**R66 Aux Fuel Tank Installation Relay Upgrade Kit Instructions**  
*(To comply with R66 Service Bulletin SB-24)*

**FIGURE 1**  
(view looking aft)

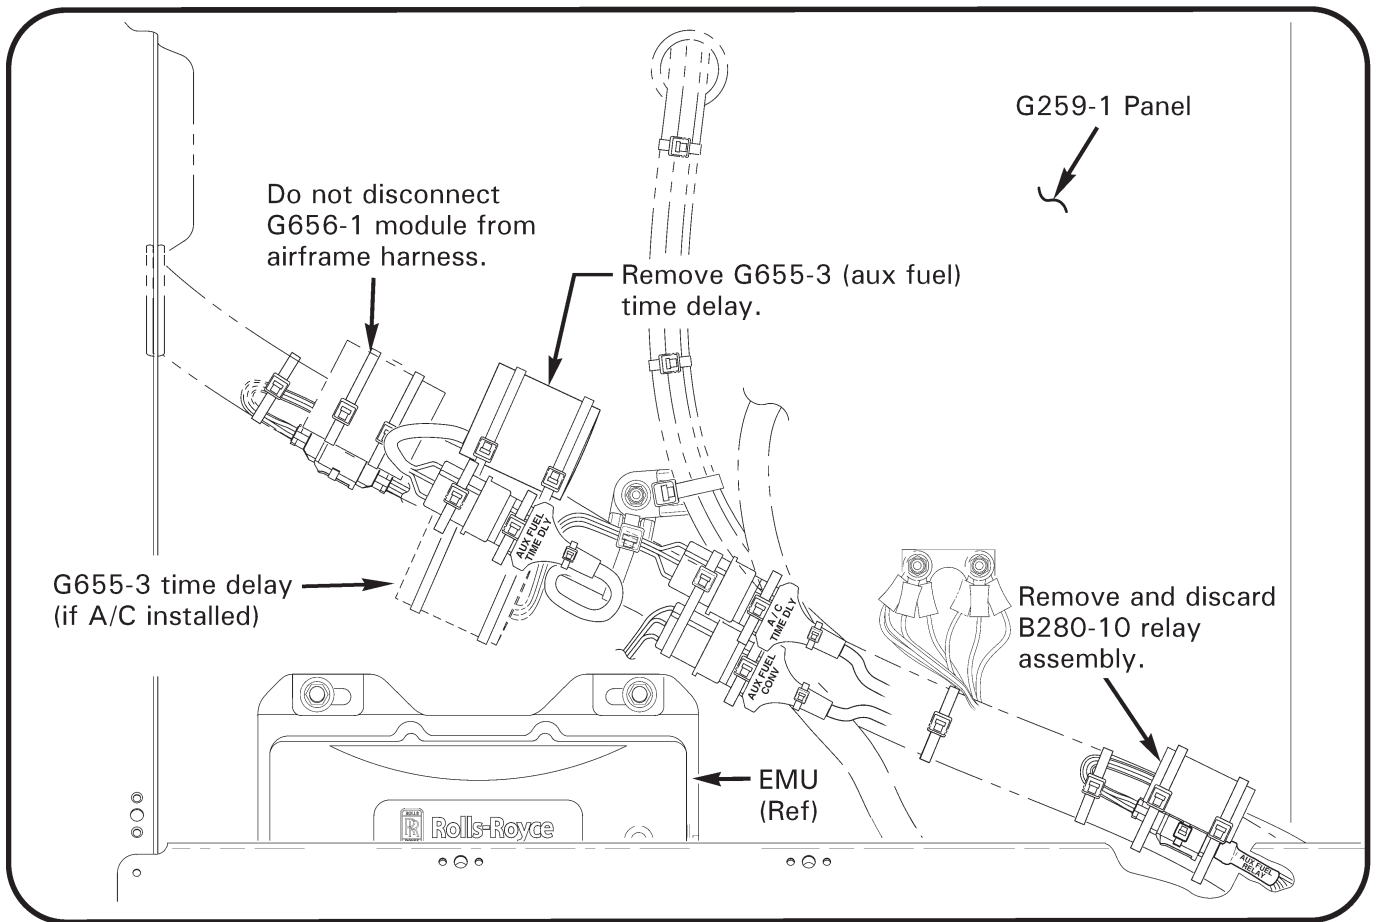
1. Remove aux tank per R66 Maintenance Manual (MM) § 28-51.
2. Remove aft, right seat back (back rest) assembly per MM § 25-22.
3. Refer to Figure 1. Locate G655-3 time delay connected to airframe harness plug labeled “AUX FUEL TIME DLY”. Disconnect aux fuel time delay and remove. Determine if (removed) time delay is affected by R66 SB-24; discard if affected by SB-24, otherwise retain as spare, if desired.

7. Refer to Figure 3. Install time delay relay using (2) MS27039C0807 screw, (2) NAS1149FN816P washer, and (2) MS21042L08 nut. Verify security.
8. Refer to Figure 1. Locate B280-10 relay assembly connected to airframe harness plug labeled "AUX FUEL RELAY". Disconnect relay, remove and discard. Connect D835-4 harness assembly to [removed relay] airframe plug. Secure connector using (1) MS3367-4-9 ty-rap. Cinch ty-rap until snug without over-tightening, and trim tips flush with heads. Verify security.

**FIGURE 2**  
(view looking aft)

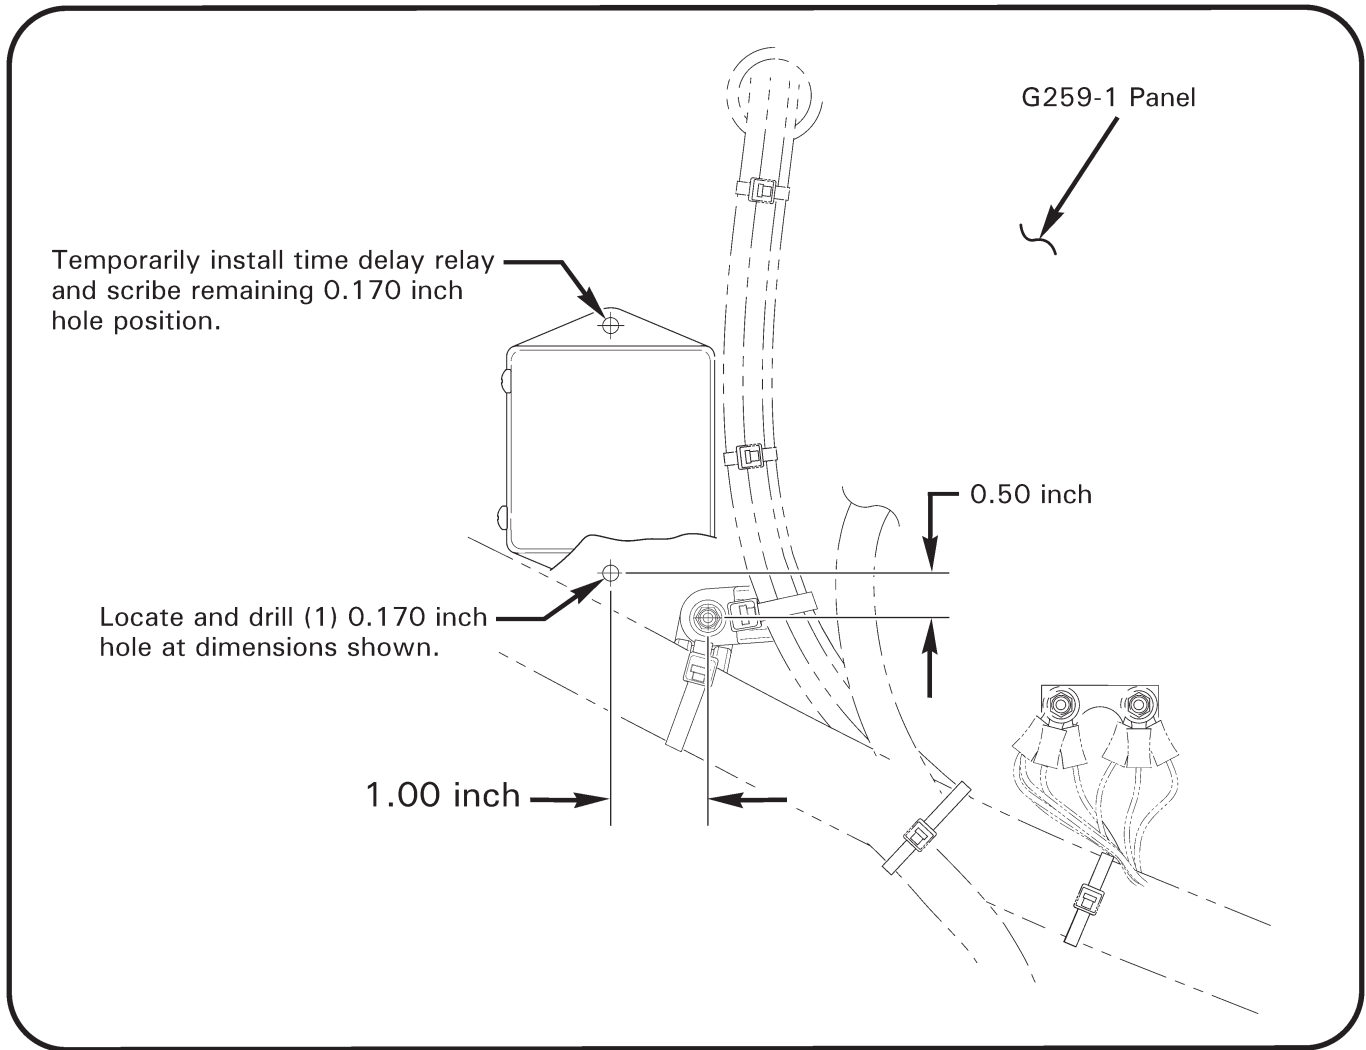
6. Refer to Figure 2. Lay out (lower) hole location for XESR10-S01-FP-0787 time delay relay as shown. Position vacuum cleaner nozzle adjacent to capture debris. Drill (1) 0.170-inch hole. Deburr hole and clean up debris. Temporarily install time delay relay in newly drilled hole using appropriate sized CLECO sheet metal fastener. Using time delay relay as template, trace remaining hole with scribe. Remove time delay relay and using vacuum cleaner, drill (1) 0.170-inch hole thru center of scribed hole. Deburr hole and clean up debris.

**FIGURE 3**  
(view looking aft)

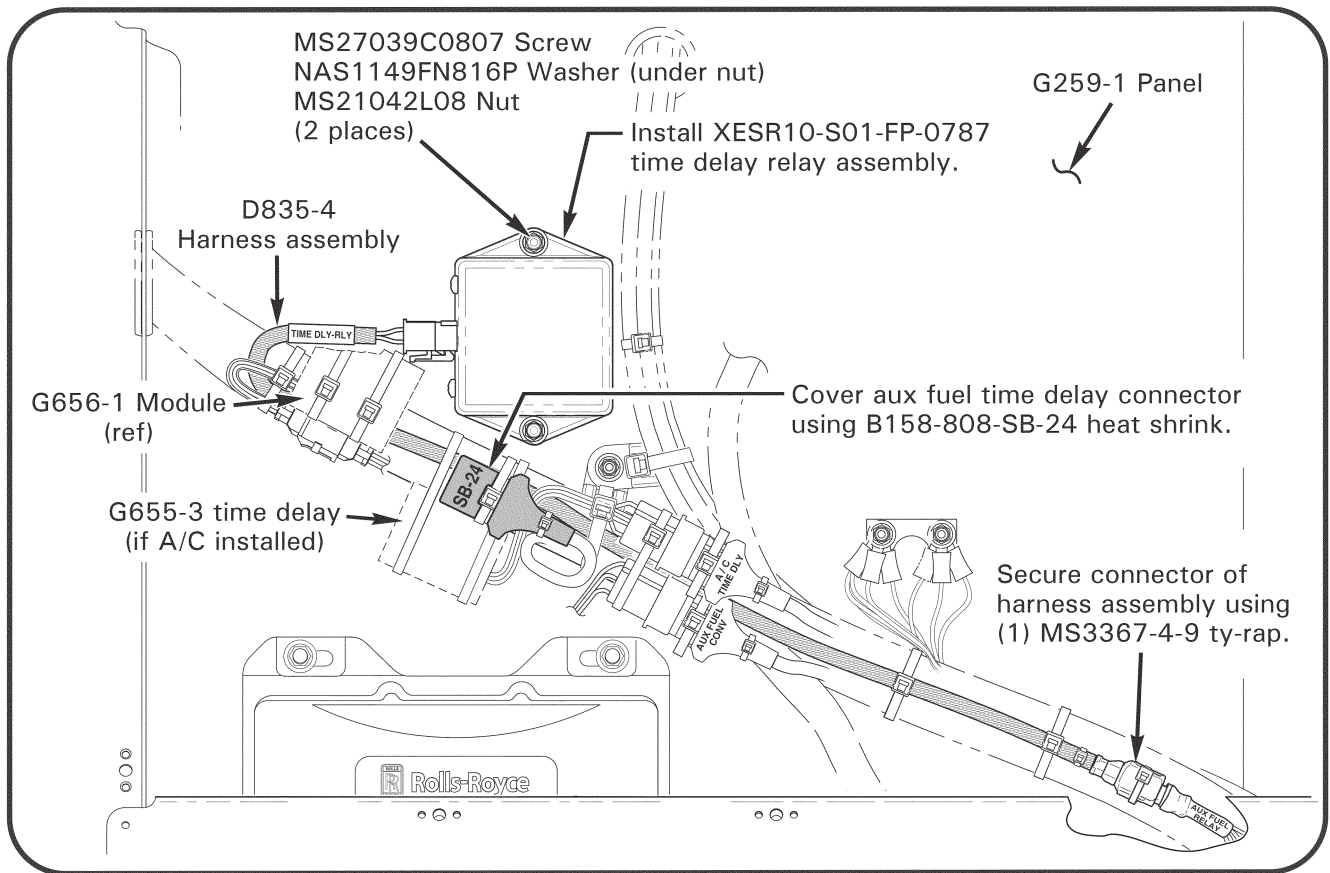
4. Refer to Figure 3. Slide B158-808-SB-24 heat shrink over [removed time delay] airframe connector (marked “AUX FUEL TIME DLY”) so “SB-24” is visible and apply heat. Verify connector is insulated and heat shrink is secure.
5. Refer to Figure 1. Remove ty-raps securing G656-1 module (generator-reset) to harness but do not disconnect attached connector. If air conditioning (A/C) is installed, locate G655-3 time delay connected to airframe harness plug labeled “A/C TIME DLY” and remove ty-raps securing time delay.

9. Refer to Figure 3. Route D835-4 harness assembly along airframe main harness as shown. Connect harness assembly to newly installed XESR10-S01-FP-0787 time delay relay.
